EARTHWORK QUALITY CONTROL OVERVIEW
AND AS-BUILT DRAWINGS
CONSTRUCTION OF STAGE I
TAILINGS IMPOUNDMENT AND DAM
SHOOTARING CANYON URANIUM PROJECT
Garfield County, Utah

PLATEAU RESOURCES LIMITED
772 Horizon Drive
Grand Junction, Colorado 81501

July 28, 1982

Figure 4

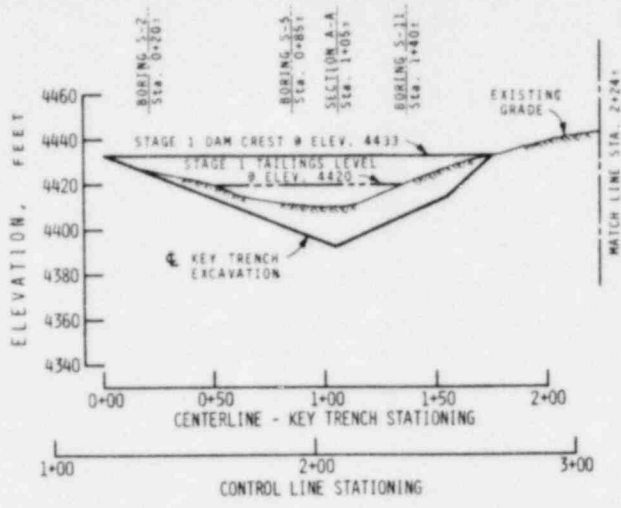
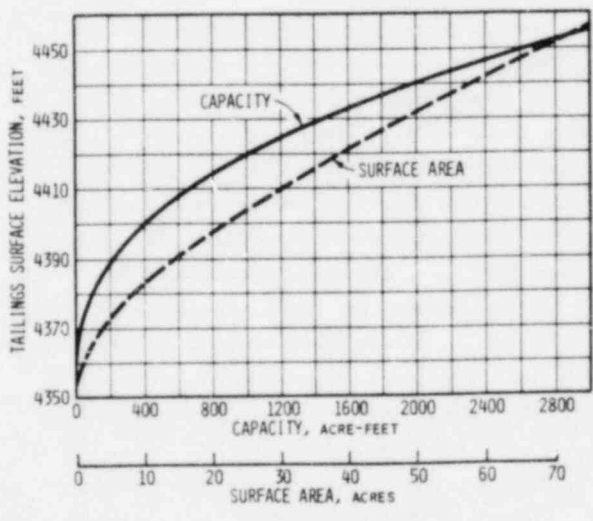
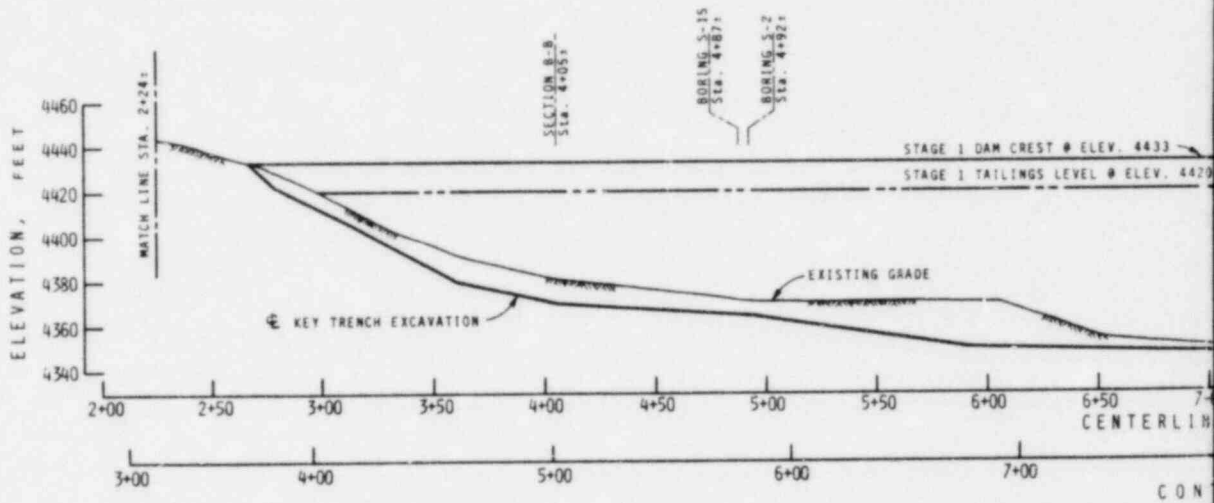
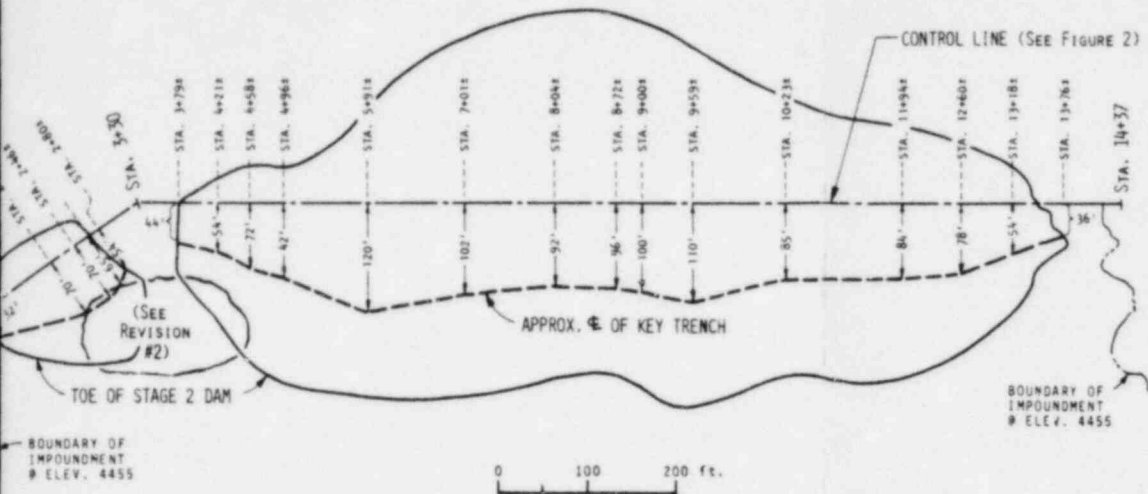
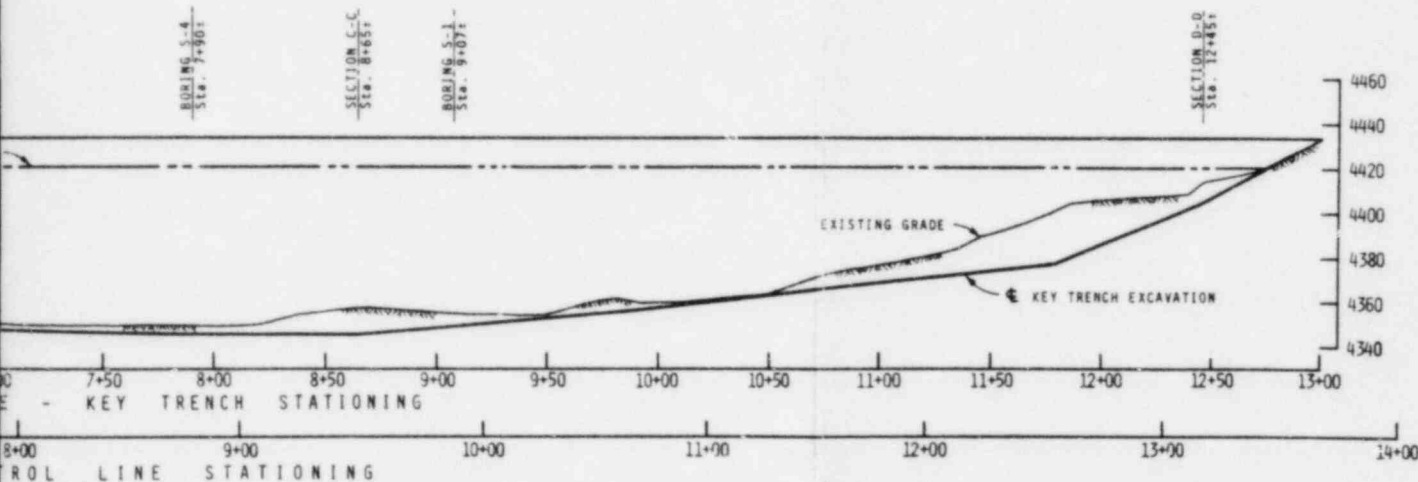
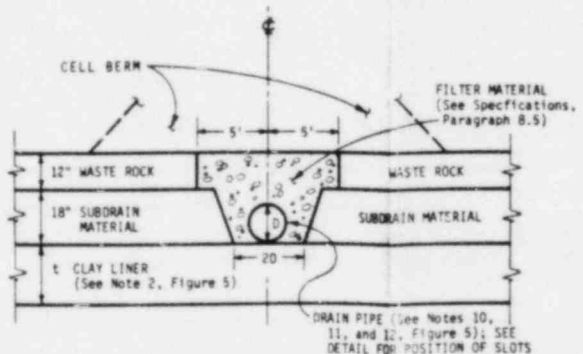
**PROFILE - SADDLE SECTION
AT KEY TRENCH**
(SEE REVISION #2)

DETAIL B: CROSS VALLEY BERM, TYPICAL SECTION
NOT TO SCALE (SEE REVISION #2)

NOTE:
 THE FINAL ALIGNMENT OF THE KEY TRENCH IS SUBJECT TO THE FIELD CONDITIONS AND MAY BE ADJUSTED BY THE ENGINEER.
 (SEE REVISION #2)

PROFILE - MAIN VALLEY SECTION AT KEY TRENCH
 (SEE REVISION #2)

No.	DATE	REVISIONS	BY
2	6-23-82	See Revision #2 on Figure 3	BBG
1	4-8-80	CORRECTED DETAILS A & B. PROVIDED NEW PIPE DETAILS UNDER CELL BERMS & NOT UNDER BERMS!	BBG/DAP

Project No. 60255J
Woodward-Clyde Consultants
 Figure 5

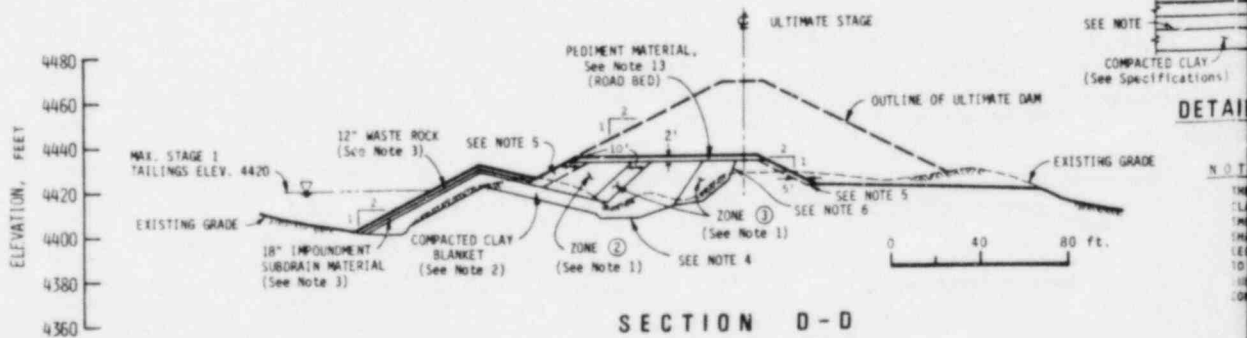
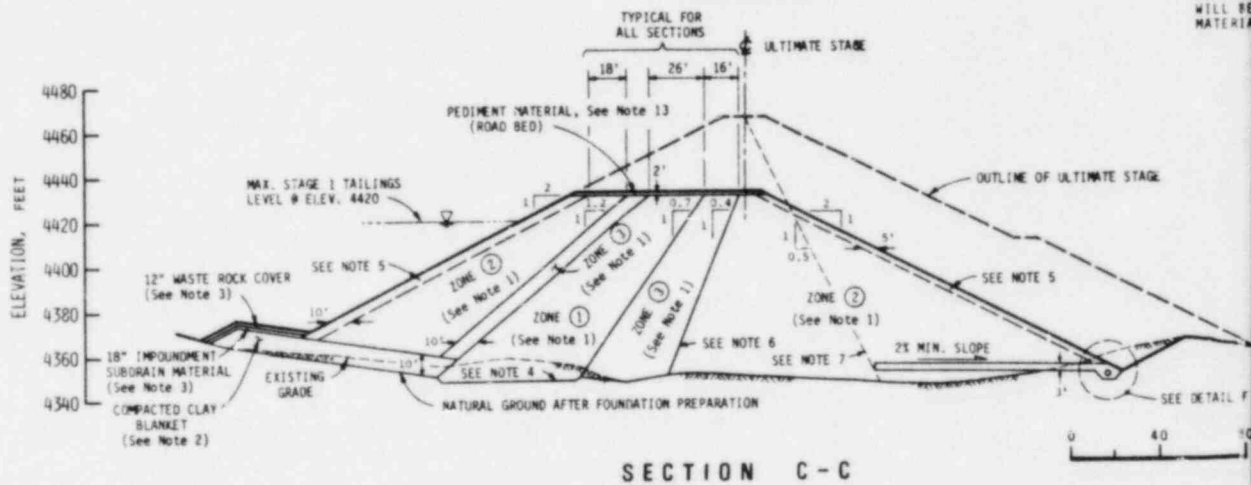
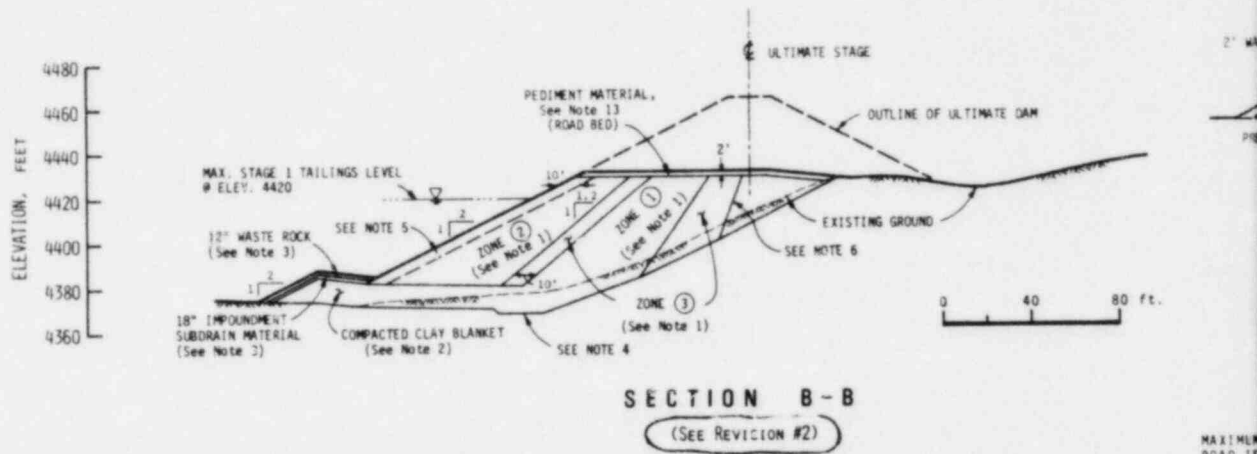
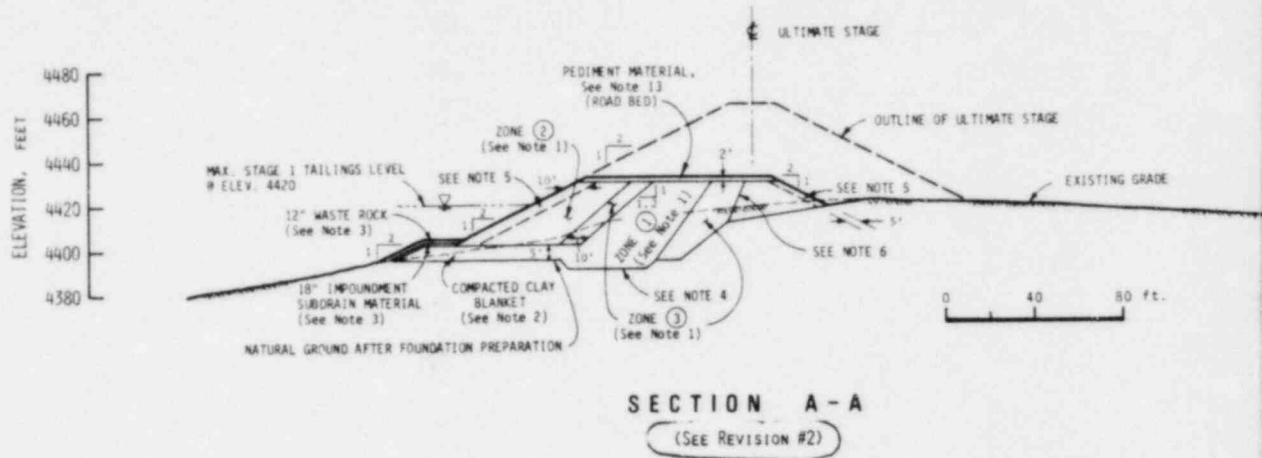
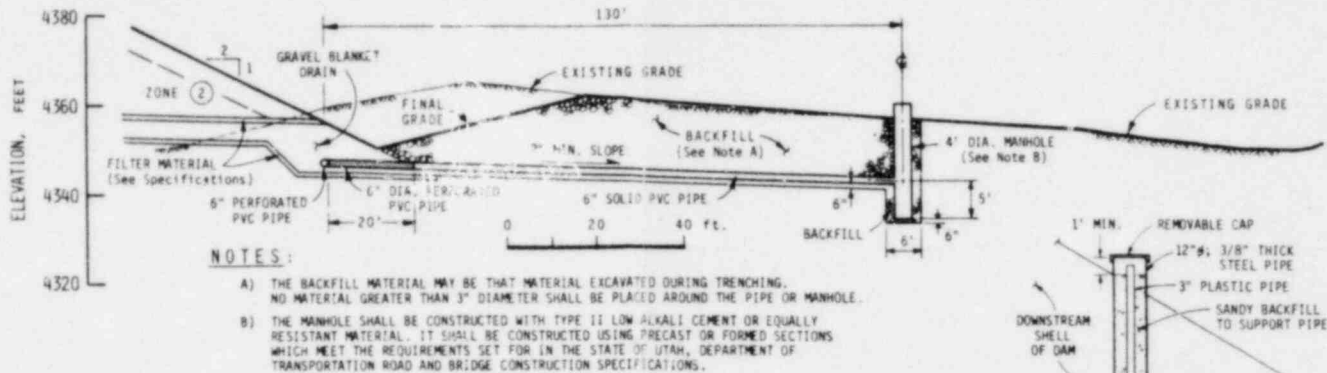
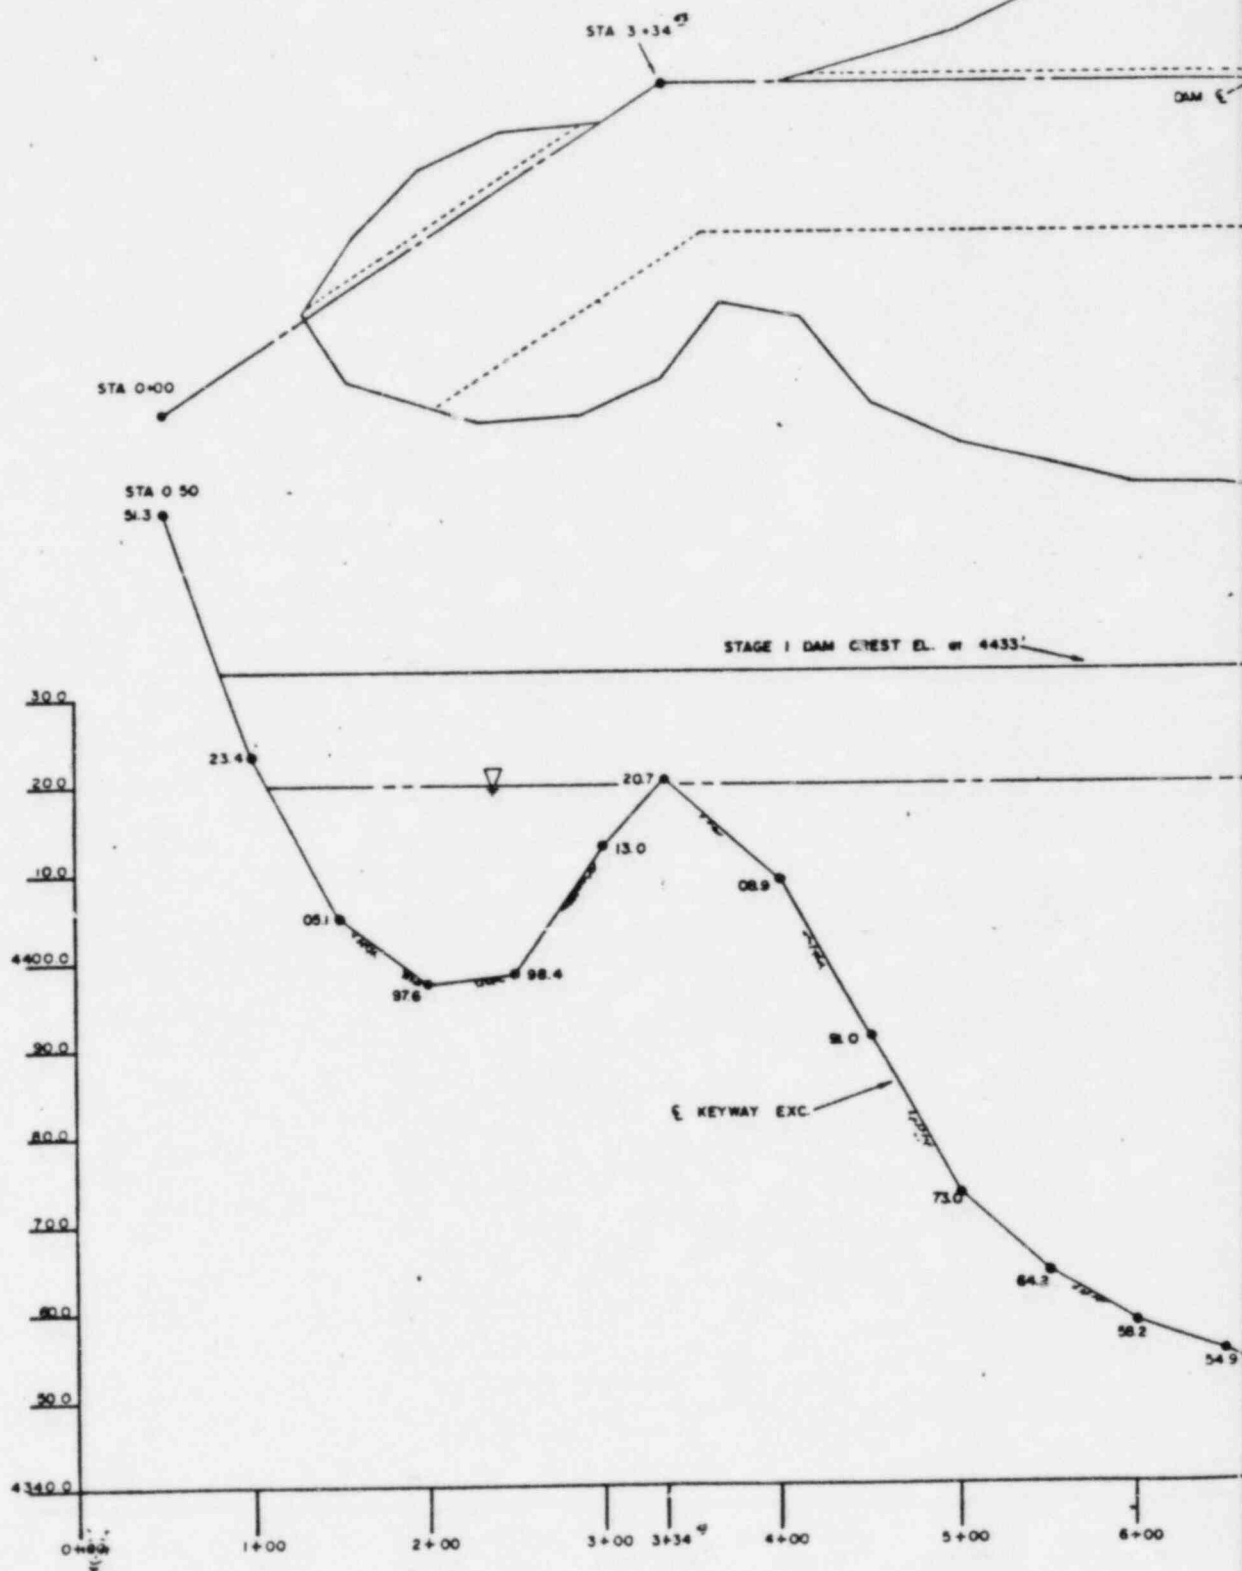
No.	DATE	REVISIONS	By
2	6-23-82	AS-BUILT Corrections are shown on MSME Drawing I-4 or as noted in Revision #2 on Figure 3.	BBG
1	4-8-80	CORRECTED DETAIL D; ADDED NOTE 15, DETAIL H, & NOTE TO DETAIL G; MODIFIED NOTES 2, 10, 11, & 12	BBG/DAF
